TCM-S63/S64V/S65/S66V

SONY. SERVICE MANUAL

SUPPLEMENT-1

Subject : Change of REC/PB Head

Page 11

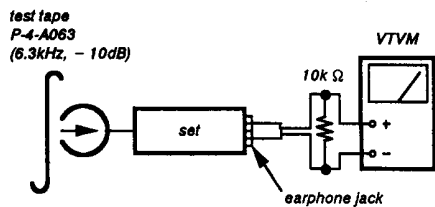
Ref. No.	Part No.	Description	Ref. No.	Part No.	Description
108	3-385-721-01	GUIDE, HEAD	108	<u>3-907-591-01</u>	GUIDE, HEAD
109	3-385-723-01	SCREW	109	<u>3-907-592-01</u>	SCREW
123	_____		123	<u>3-907-593-01</u>	WASHER
124	_____		124	<u>3-907-594-01</u>	SPRING
HRP901 1-543-607-21 HEAD, MAGNETIC (REC/PB)			HRP901 <u>1-543-410-11</u> HEAD, MAGNETIC (REC/PB)

The record/playback head azimuth adjustment is requested due to this change.

Record/playback Head Azimuth Adjustment

Procedure :

1. Mode : Playback

2. Turn the adjustment screw to obtain the maximum reading on VTVM.

Note : Several peaks may appear, but take the maximum.

3. After the adjustment, lock the adjustment screw with suitable locking compound.
